Master Plan Amendment #2020-00009

CDD Concept Plan #2020-00007

Landmark Neighborhood – 5701, 5701B, 5801, 5815, 5901 Duke Street

Staff Recommendation: APPROVAL WITH CONDITIONS

Figure 1: Framework Plan and Complete Streets Typology

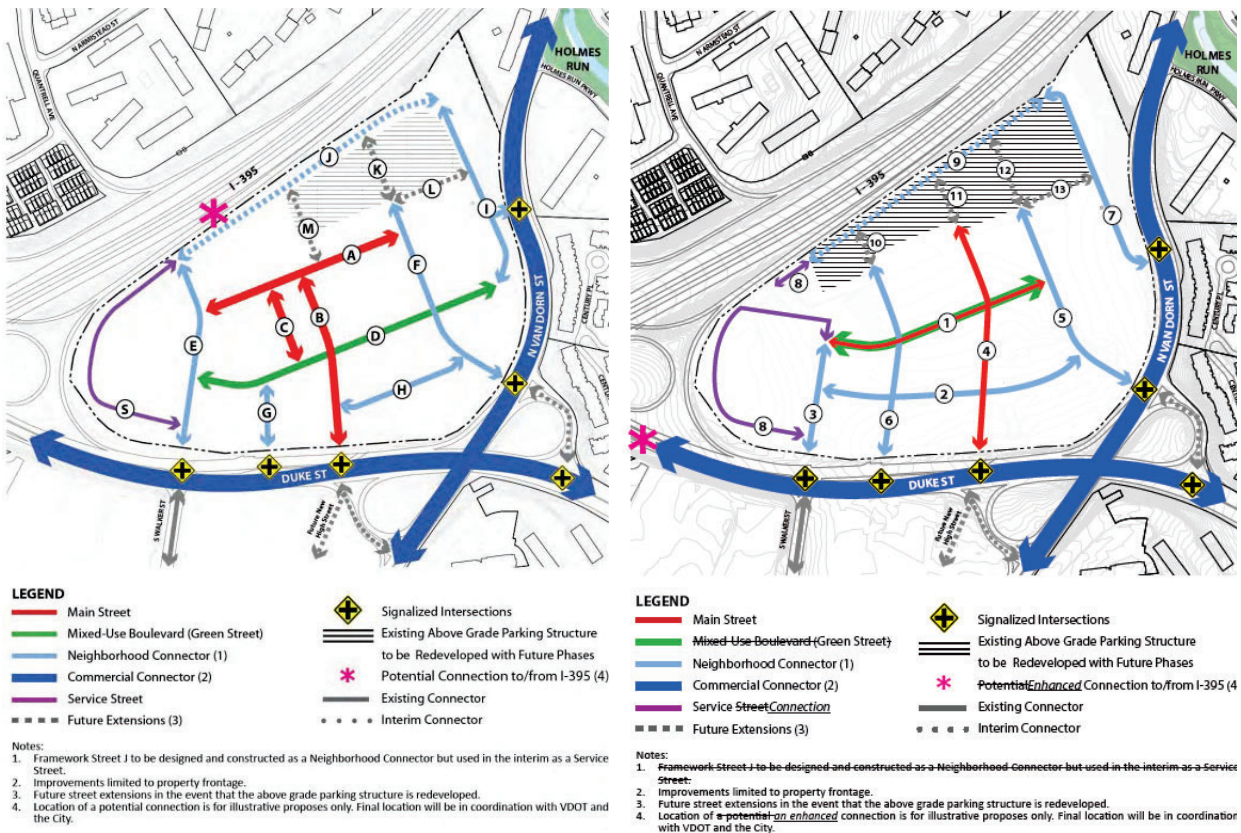
Staff supports the proposed street alignments and finds the proposal consistent with the intent of the Plan, which is to ensure a connected development with short, pedestrian-oriented block lengths. The southward shift of east/west Streets 1 and 2 (Streets A and D in the Plan) creates rationally sized blocks along the existing parking garage.

in Figure 1, the applicant proposes Street 2 to function as a Neighborhood Connector, as opposed to a Mixed-Use Boulevard (Street D), as prescribed by the Plan.

Envisioned as a wider boulevard with a transit hub, Street D in the Plan was intended to serve as a “green” spine connecting all publicly accessible parks and open spaces across the site with sustainable design elements and stormwater best management practices. Street 2 will provide the transit hub in the general location outlined in the Plan, and the green street elements and bicycle facilities will be incorporated into proposed Street 1. This fulfills the purpose of connecting the publicly accessible open spaces and complements the retail and open space core.

Figure 2: Transit Hub

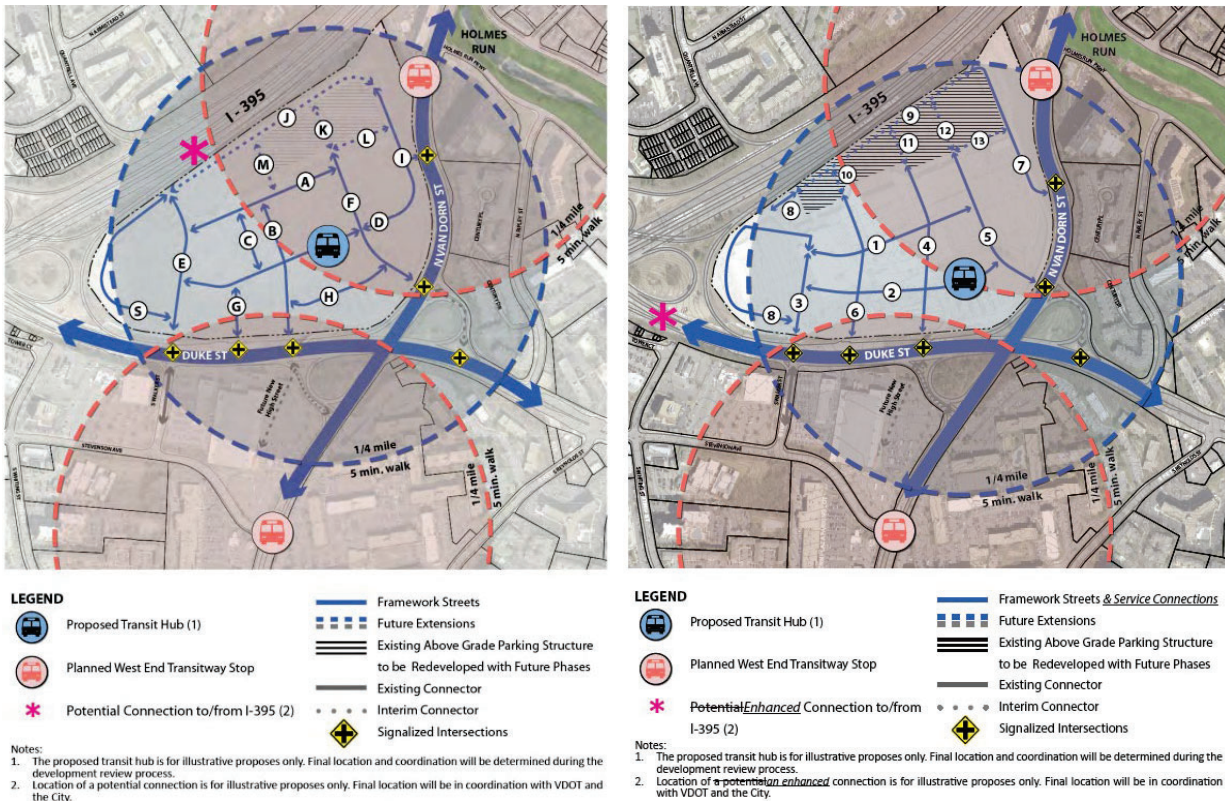
The applicant proposes to slightly modify the location of the transit hub to the south on the site due to the reconfigured street network, as shown in Figure 2. Staff supports the proposed location of the transit hub between Streets 4 and 5 on Street 2 as it is shown generally in the location intended by the Corridor Plan to support greater access and use of transit as an efficient and convenient transportation option. The proposed street framework eliminates the needs for Street H in the Plan, allowing for a more prominent location of the hub one block closer to the entrance of the site.

Figure 3: VDOT Proposed Improvements for Duke Street Bridge

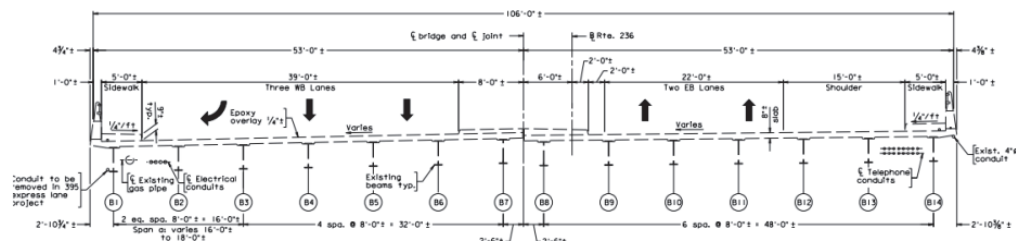
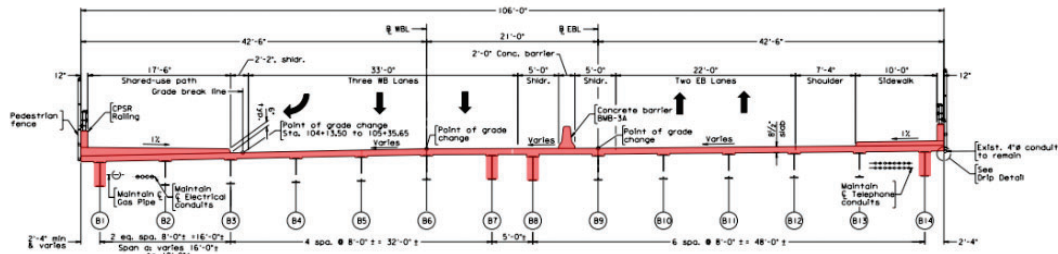
Staff will continue to work with VDOT and FHWA to provide an enhanced vehicle connection from I-395 (northbound) to the site, along the Duke Street from the northbound exit ramp to the Duke Street and S. Walker Street intersection. The Corridor Plan recommends a potential ramp connection to I-395 as seen in Figures 1 and 2 (pink asterisk, left graphic), above, with the acknowledgment that the final location would be in coordination with VDOT and the City. Staff supports the alternative approach towards enhanced connectivity in the location described in Figures 1 and 2 (pink asterisk, right graphic). Not only will this amendment fulfil the intent of the Plan, it also aligns with current efforts by VDOT to enhance pedestrian and bicycle connectivity across the Duke Street/Little River Turnpike bridge, as seen in Figure 3. Construction by VDOT is anticipated to start Summer 2021.

Figure 4: Pedestrian and Bicycle Facilities

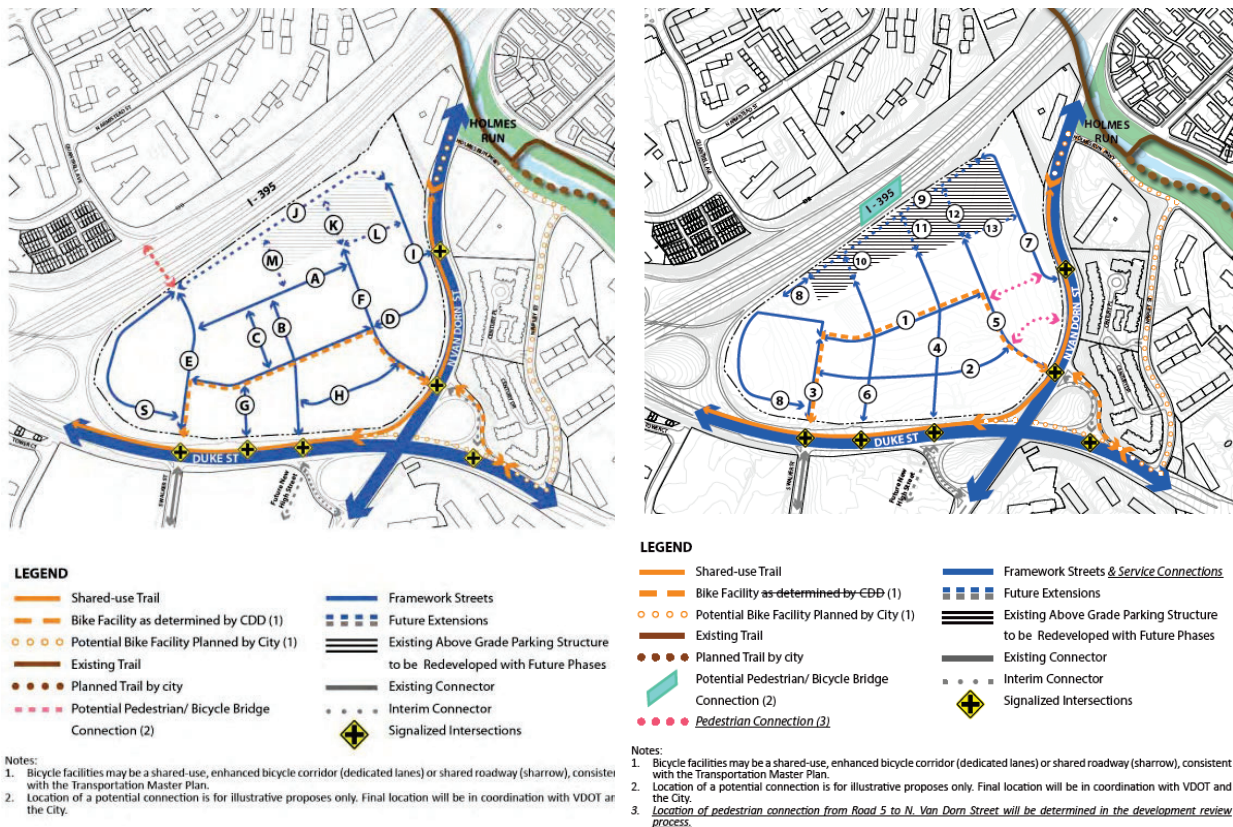
The applicant proposes to modify the plan's pedestrian and bicycle facilities network to accommodate an east/west connection along Street 1 (Street A in the Corridor Plan) instead of Street 2 (Street D in the Corridor Plan), to include pedestrian connections between Streets 5 and 7, and to update the symbol for the potential pedestrian/bicycle bridge over I-395, as depicted in Figure 4, below.

As seen in Figure 4, the proposed amendment is consistent with the intent of the Corridor Plan, which is to ensure appropriate non-automotive ingress and egress and internal bicycle connections through the site. Consistent with the Plan, the east/west bicycle connection facilitates safe cycling to the retail core and Central Plaza from two north/south connections along Streets 3 and 5.

2019 Landmark Van Dorn Corridor Plan
Figure 6: Land Use

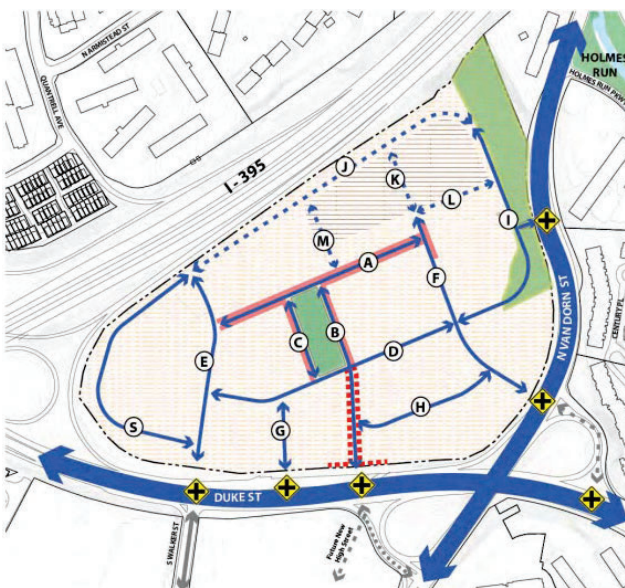
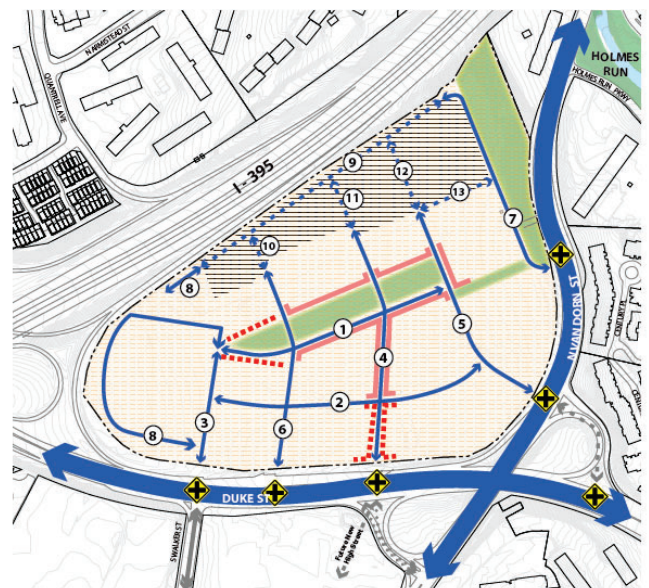
Staff supports the requested modifications to the locations of Required and Preferred Active/Retail Streets, as the intent to provide active ground floors, both in use and building design along Main Streets A, B and C in the Corridor Plan, is generally provided along proposed Main Streets 1 and 4.

Figure 7: Building Heights

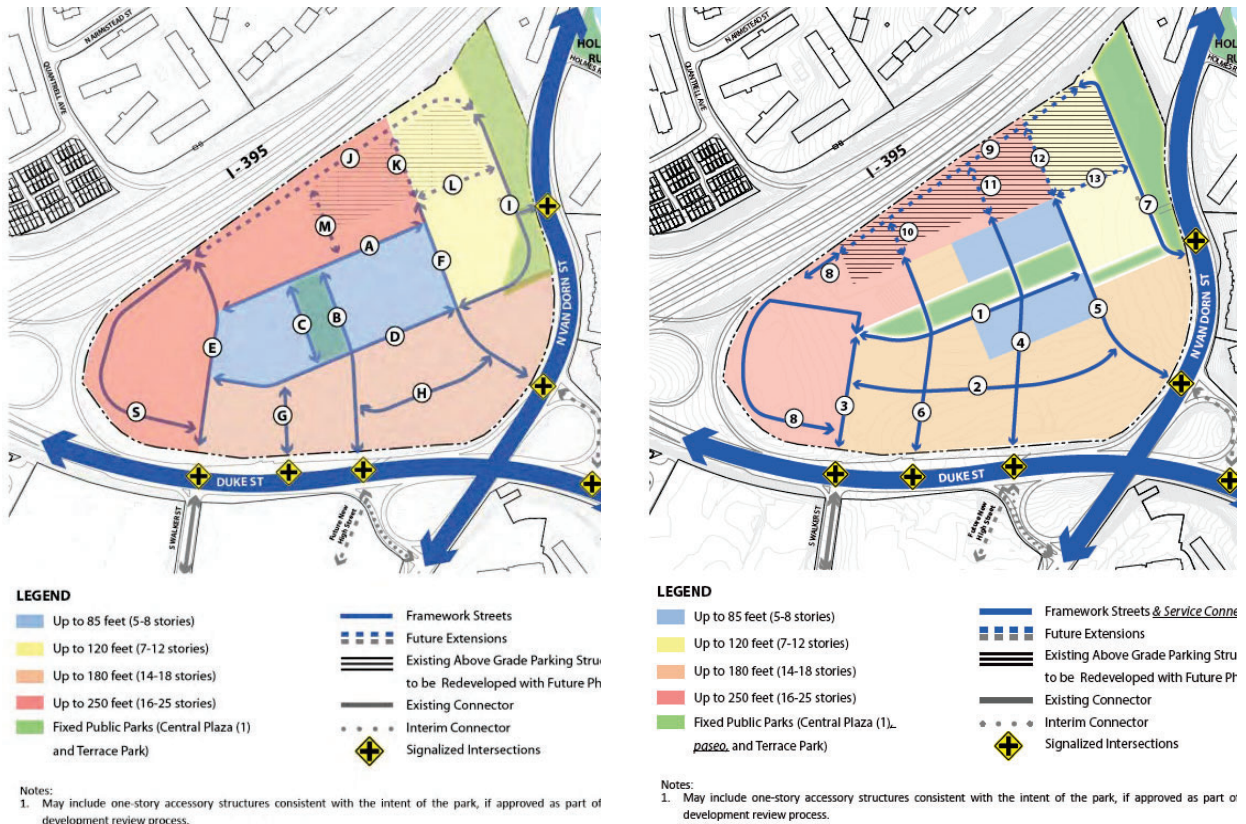
Staff supports the proposed maximum height modifications as they align with the proposed street framework and are consistent with the Corridor Plan's intent to ensure a dynamic skyline and neighborhood identity through a variety of heights.

The previously proposed maximum heights, ranging from 85 feet to 250 feet across the neighborhood, remains and generally in the locations as prescribed by the Corridor Plan. The building maximums also remain consistent, at 250 feet and generally located along the western edge and along I-395; maximums of 180 feet are located along Duke Street and portions of N. Van Dorn Street; 120 ft. maximums are maintained along the Terrace Park; and 85 ft. maximums are found flanking a block and a half of the Central Plaza.

Figure 9: Preliminary CDD Concept Plan

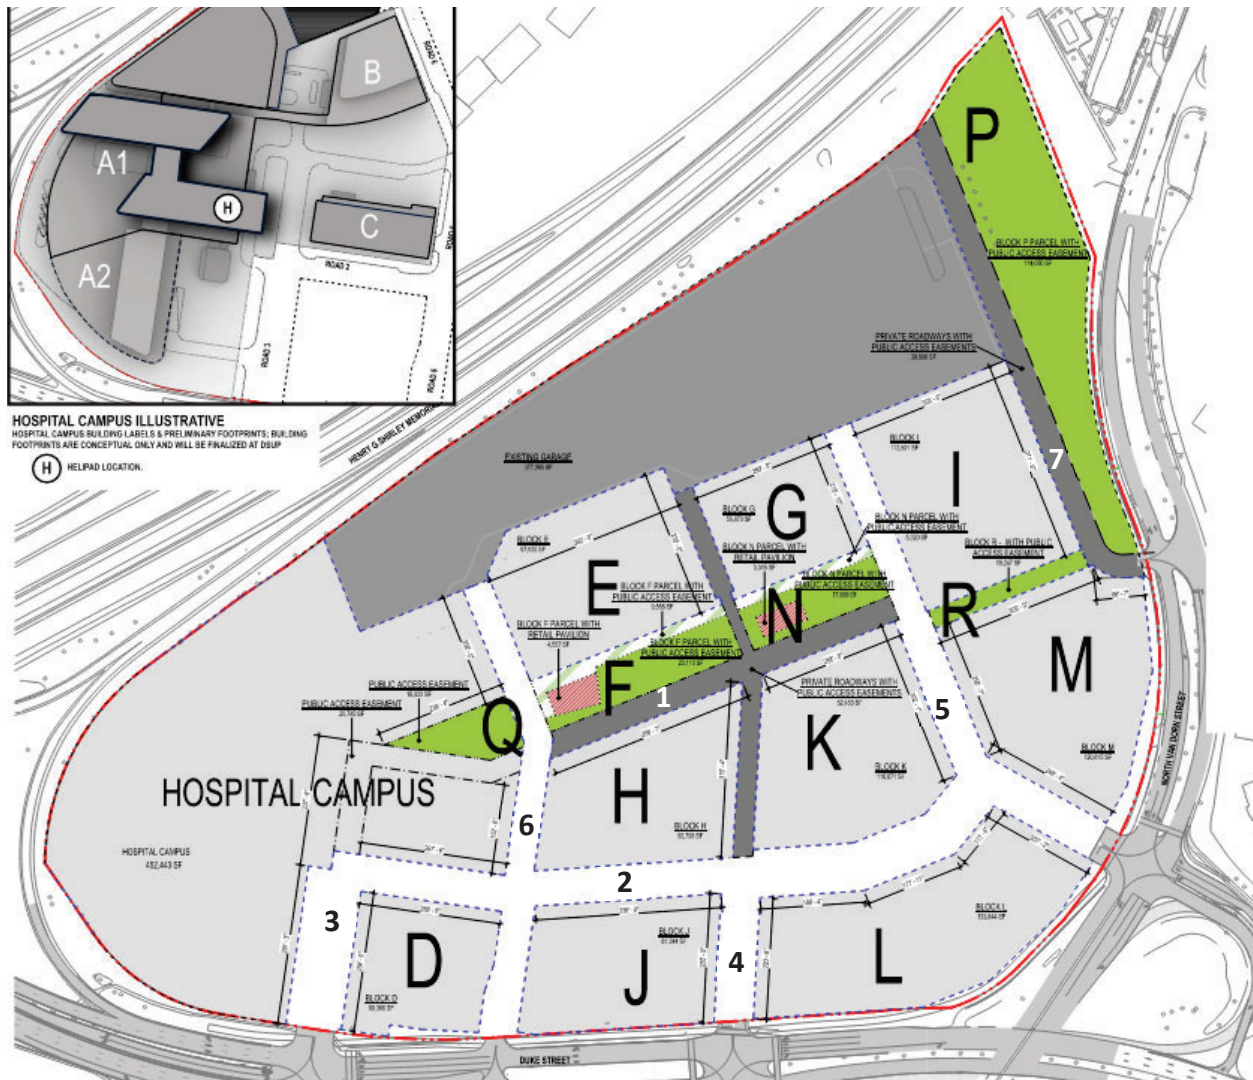
Figure 9 shows the preliminary CDD Concept Plan, including the proposed streets.

Figure 2: Framework Plan and Complete Street Typology

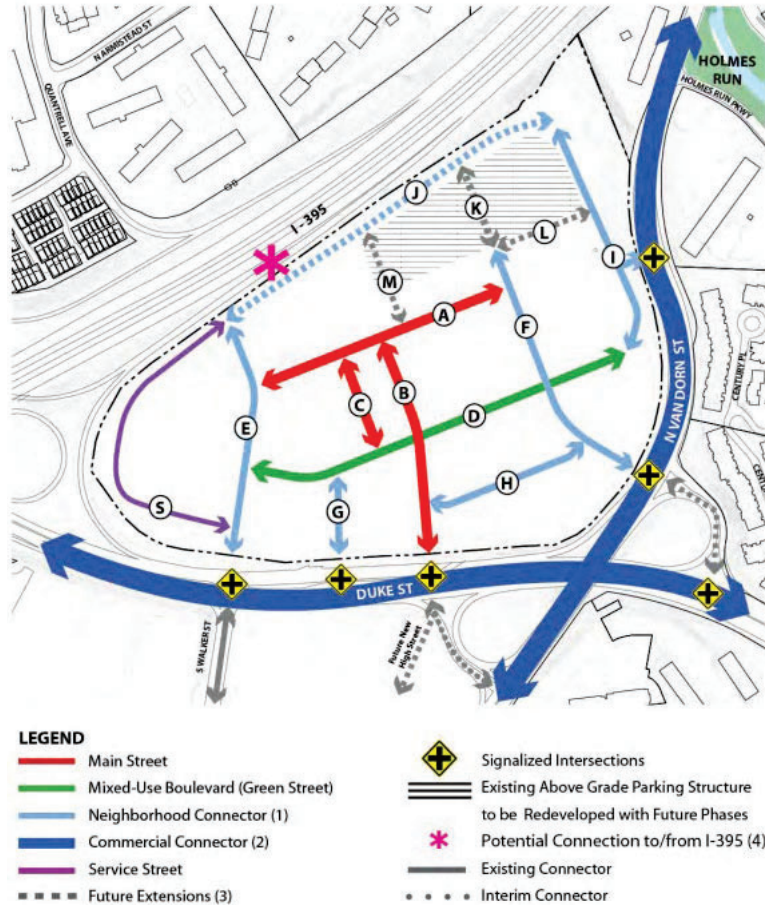
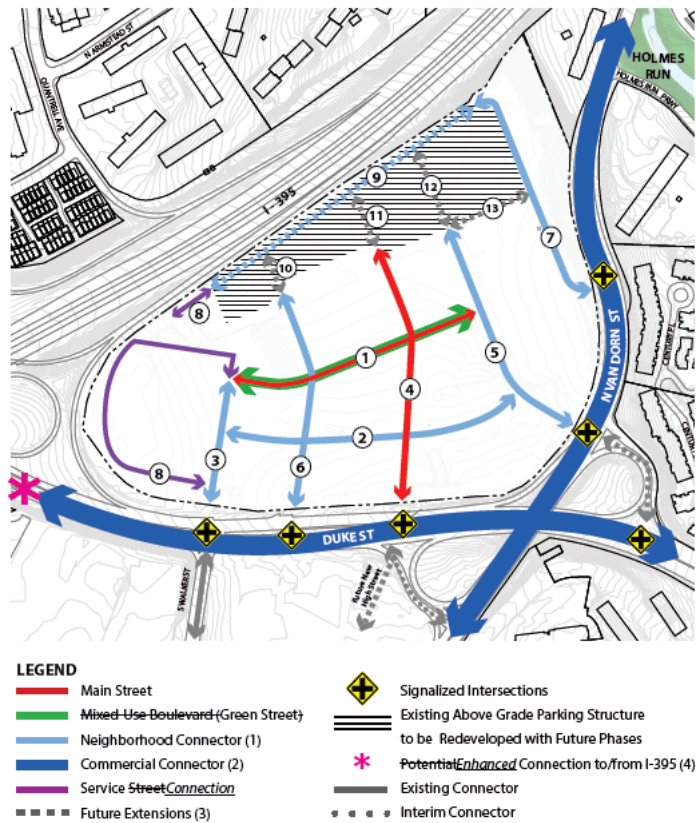
1. Framework Street J to be designed and constructed as a Neighborhood Connector but used in the interim as a Service Street.
2. Improvements limited to property frontage.
3. Future street extensions in the event that the above grade parking structure is redeveloped.
4. Location of a potential connection is for illustrative purposes only. Final location will be in coordination with VDOT and the City.

- Notes:
1. Framework Street 1 to be designed and constructed as a Neighborhood Connector but used in the interim as a Service Street.
 2. Improvements limited to property frontage.
 3. Future street extensions in the event that the above grade parking structure is redeveloped.
 4. Location of a potential enhanced connection is for illustrative purposes only. Final location will be in coordination with VDOT and the City.

Figure 10: Pedestrian and Bicycle Facilities

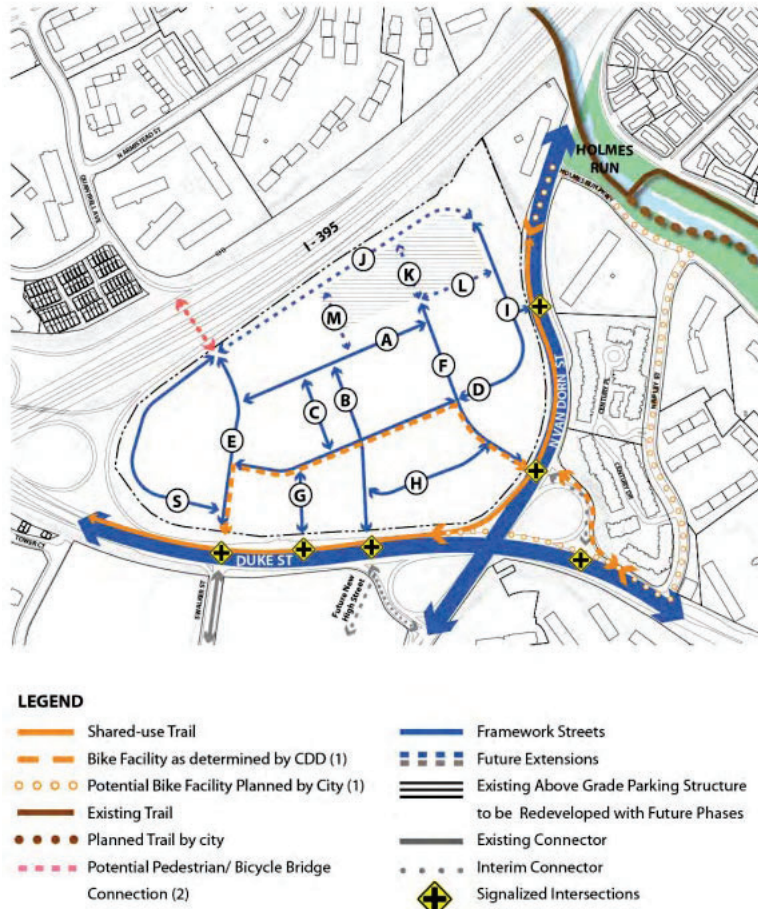
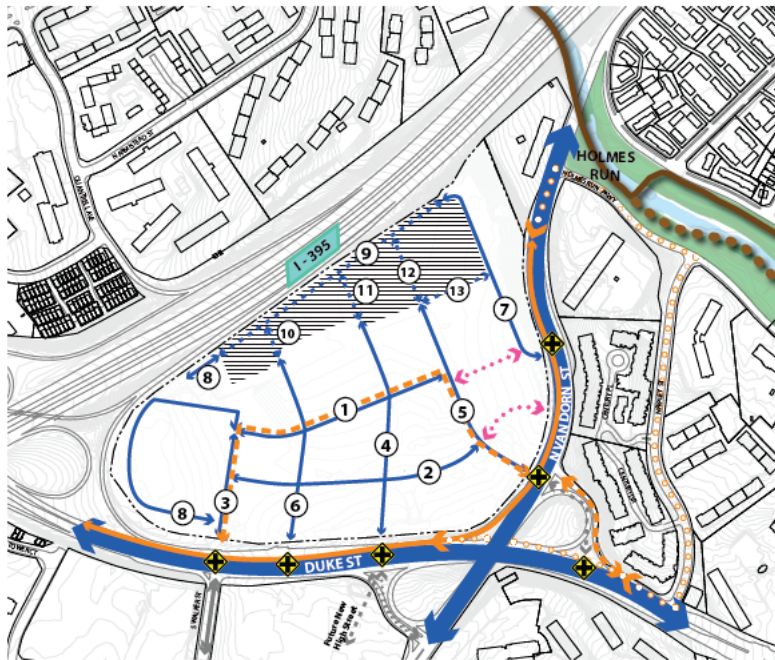
1. Bicycle facilities may be a shared-use, enhanced bicycle corridor (dedicated lanes) or shared roadway (sharrow), consistent with the Transportation Master Plan.
2. Location of a potential connection is for illustrative purposes only. Final location will be in coordination with VDOT and the City.
